January 19, 2021
Project Summary – Major Site Plan

Project: Grappone Mazda (2022-04)
Property Owner: HLF East, LLC
Address: 134 Manchester Street
Map/Block/Lot: 782Z / 40

MEMORANDUM

TO: Beth Fenstermacher, Assistant City Planner
FROM: Gary Lemay P.E., Associate Engineer
DATE: January 10, 2022
SUBJECT: Grappone Mazda Major Site Plan – Engineering Plan Review, 134
Manchester Street; Map 782Z, Lot 40; Project 2022-04

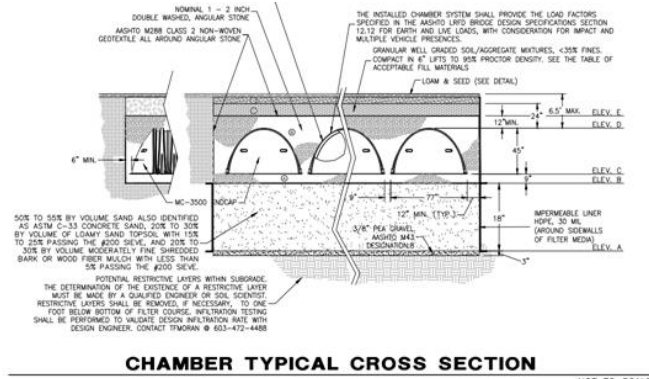
31. The sewer invert connection label at the top of the plan appears to be cut off (appears to say "Invert at Connection = 313.8")

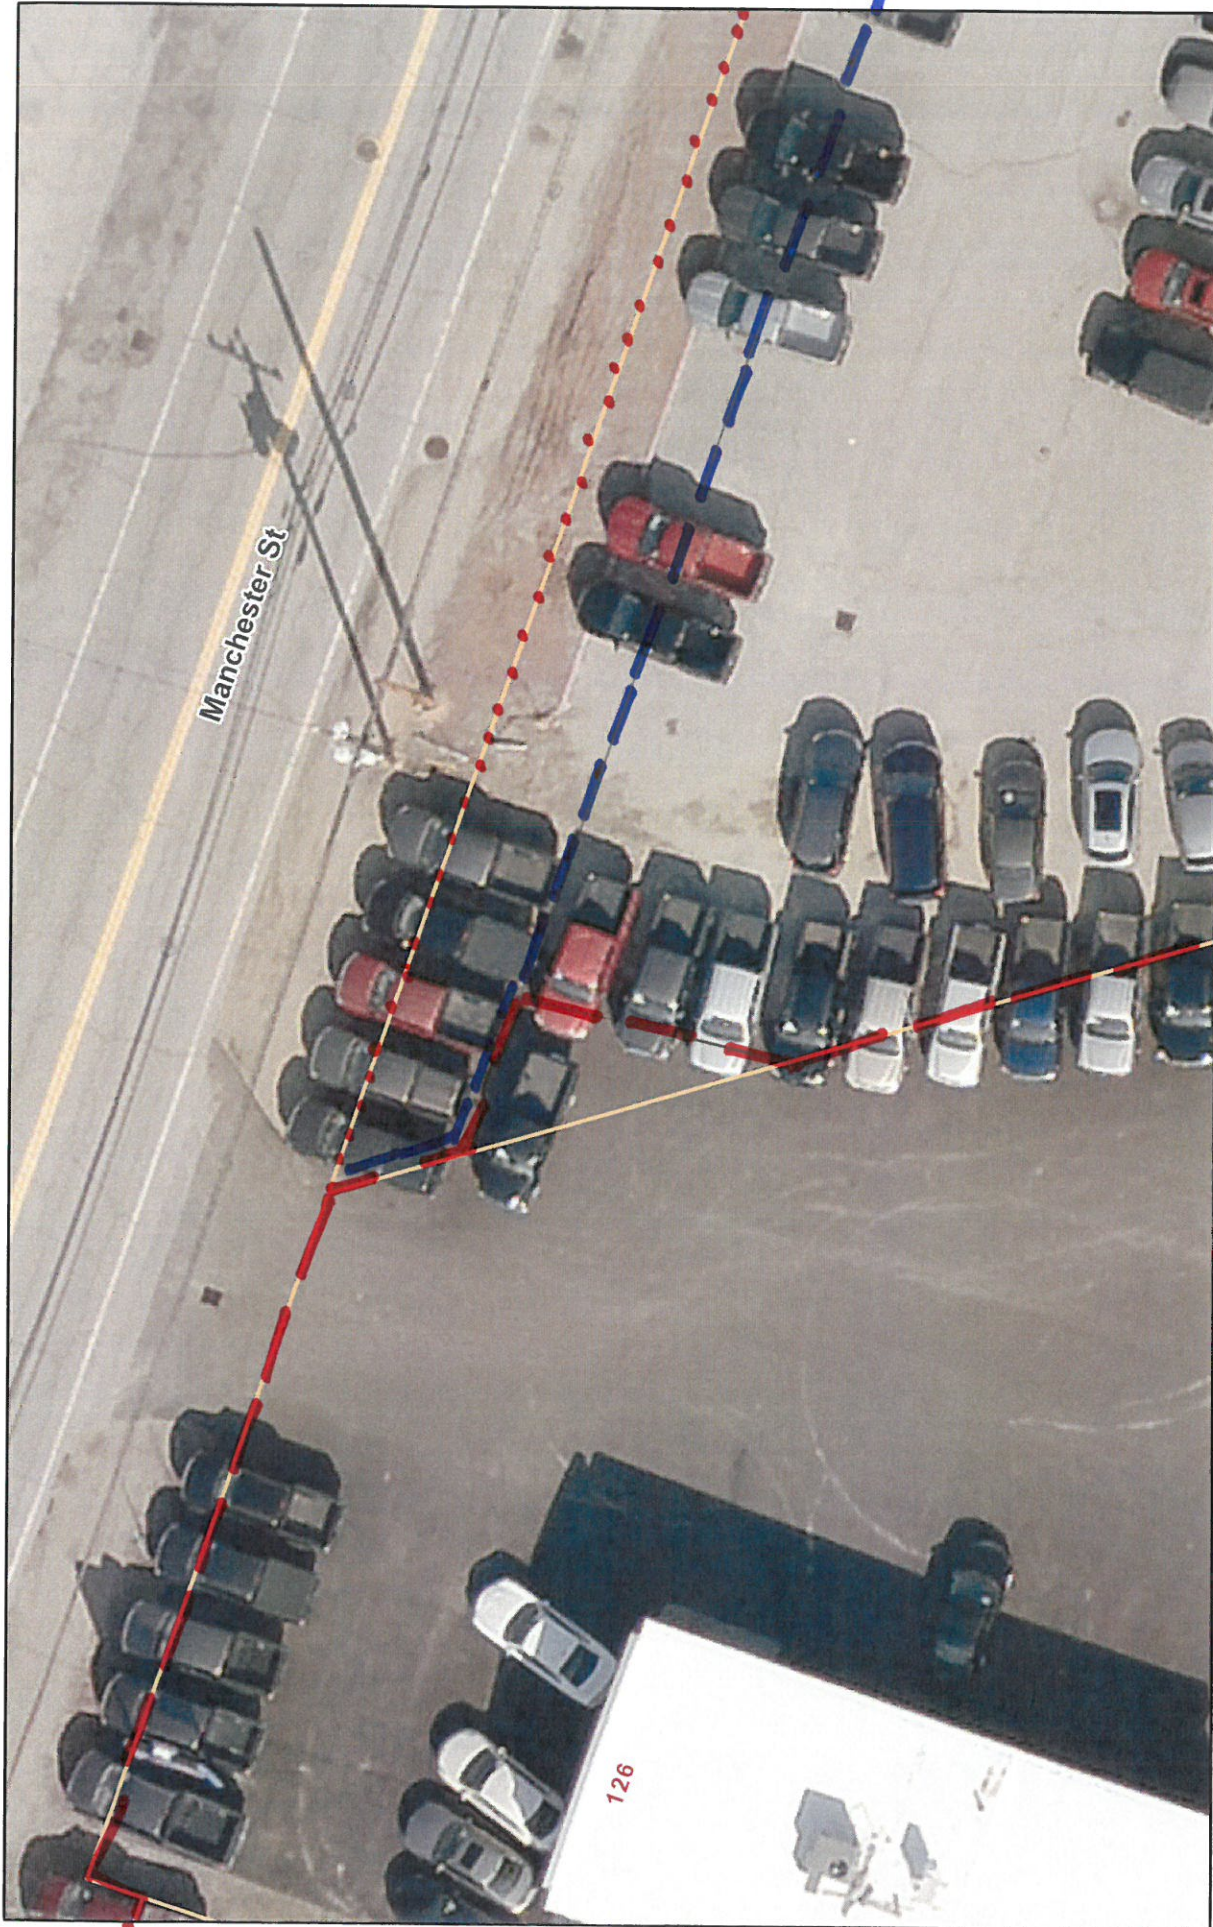
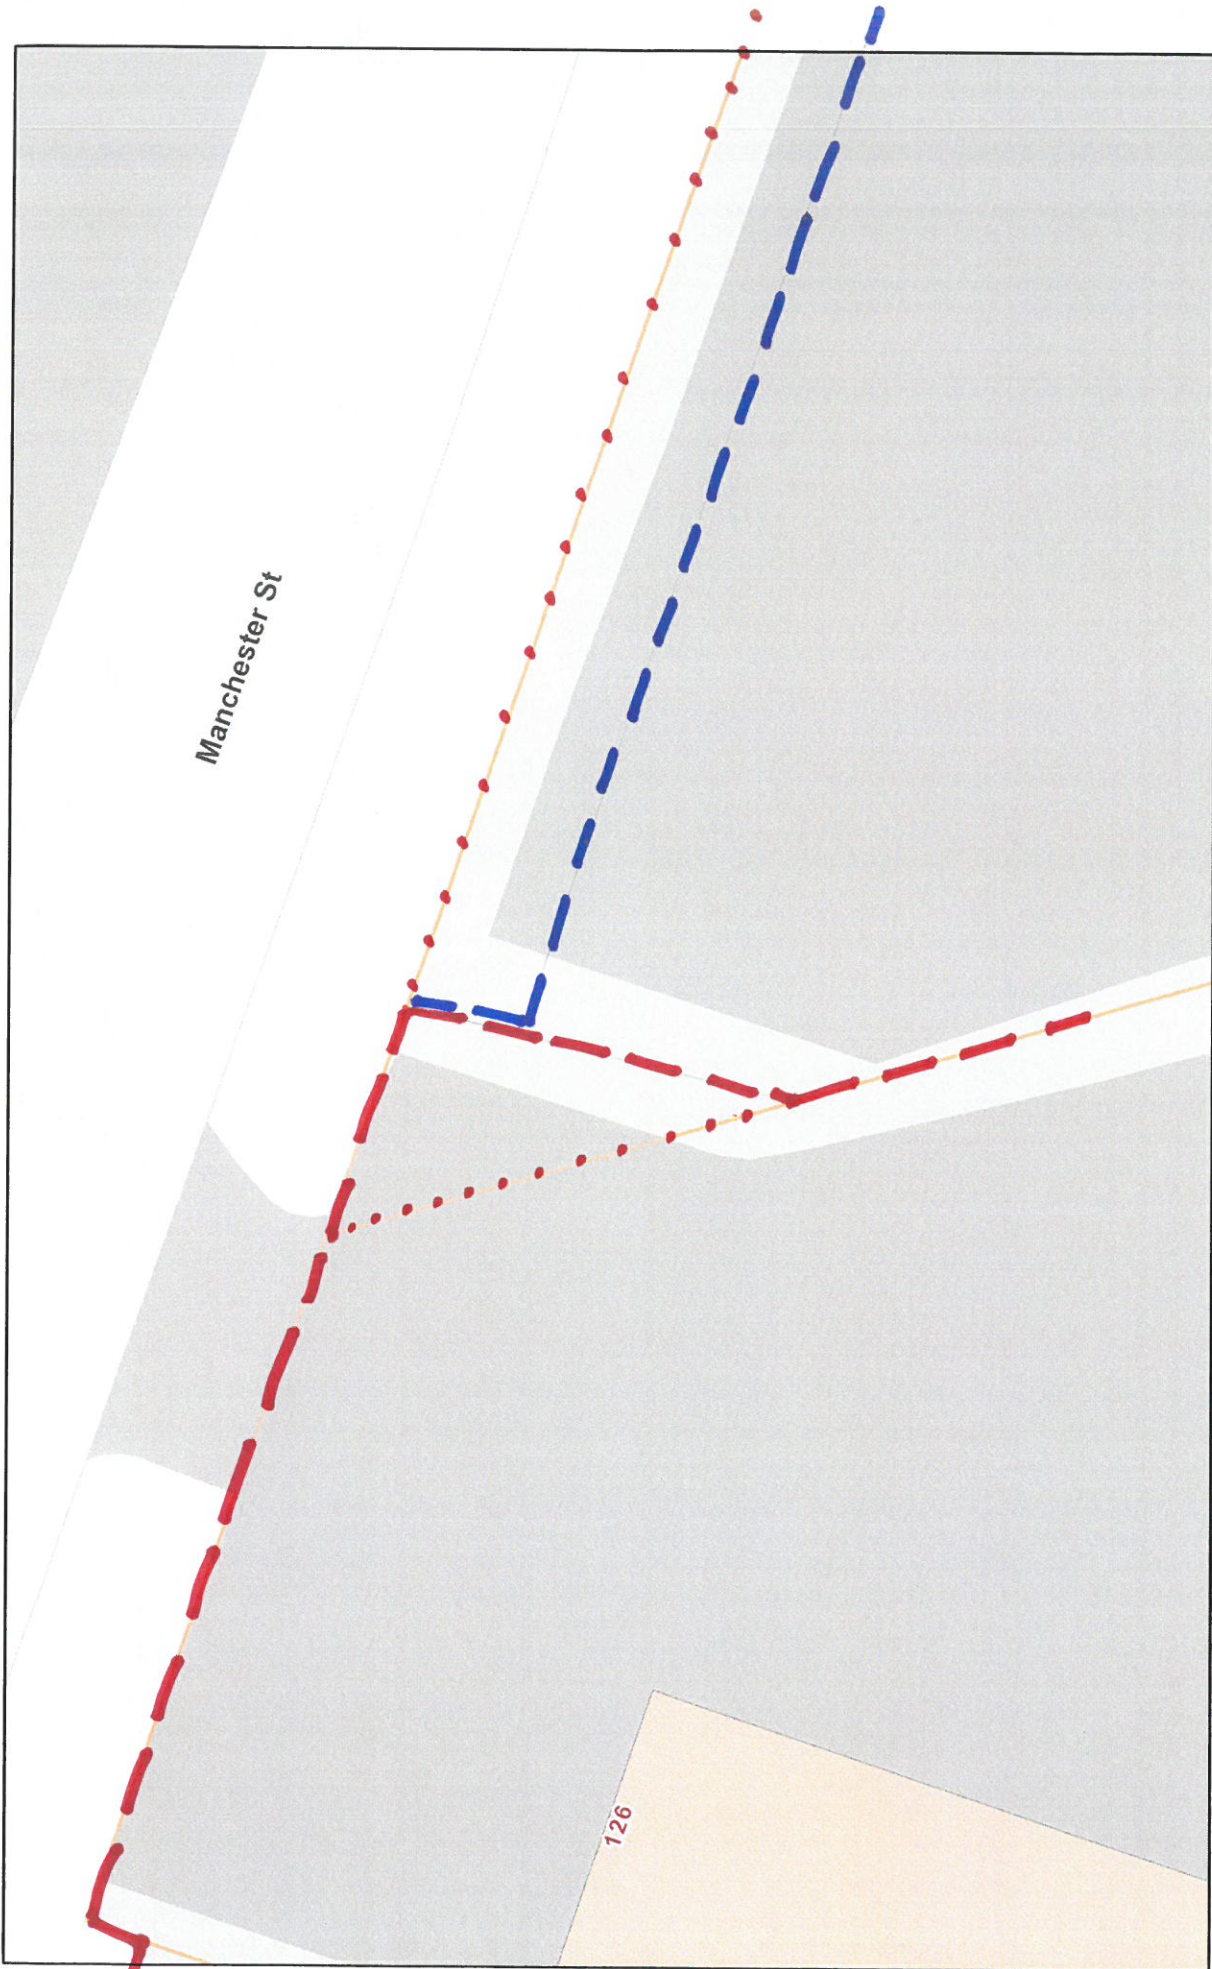
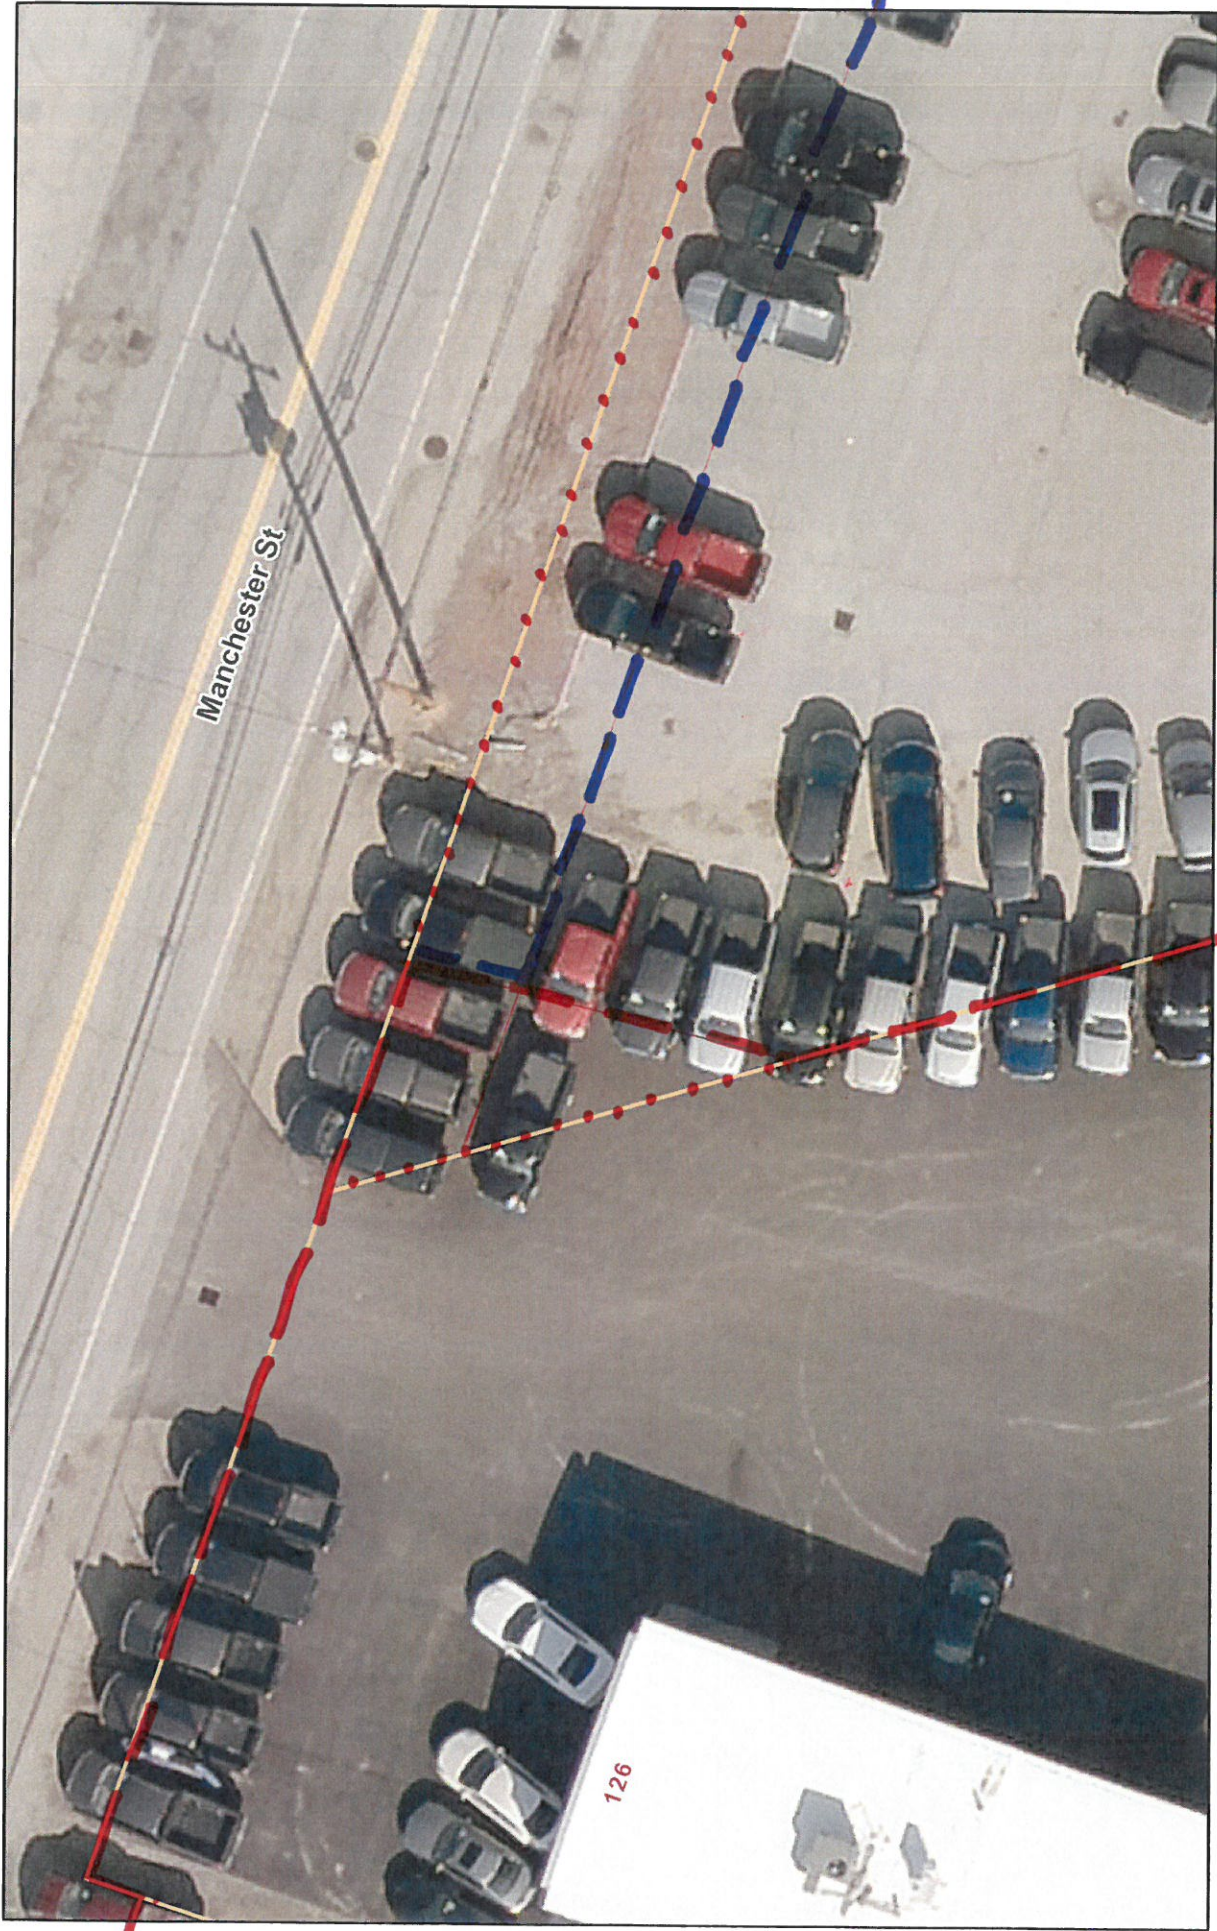
14. At the easterly end of the right-of-way to be conveyed to the City, the note for “landscape island (typ.)” is obscuring the boundary line.
15. As stated above, there is a note that states “261 SF to be annexed to Lot 17.” Engineering and City staff shall review the proposed configuration in conjunction with the conveyance of an easement for additional right-of-way. Due to the private

encroachment of improvements from 126 Manchester Street onto 134 Manchester Street, and the conveyance of land for additional right-of-way, this proposal may create unintended results. Two potential options for right-of-way conveyance have been attached to the Planning Report for reference. Engineering's recommendation is to proceed with Option 2. Please contact City staff for follow-up on this item.

- a. This item must be resolved by submission and approval of a subdivision plan prior to final Site Plan approval.
16. Bicycle parking shall be provided based on Section 30.03 of the Site Plan Regulations and the 2010 Bicycle Master Plan; and designed as follows:
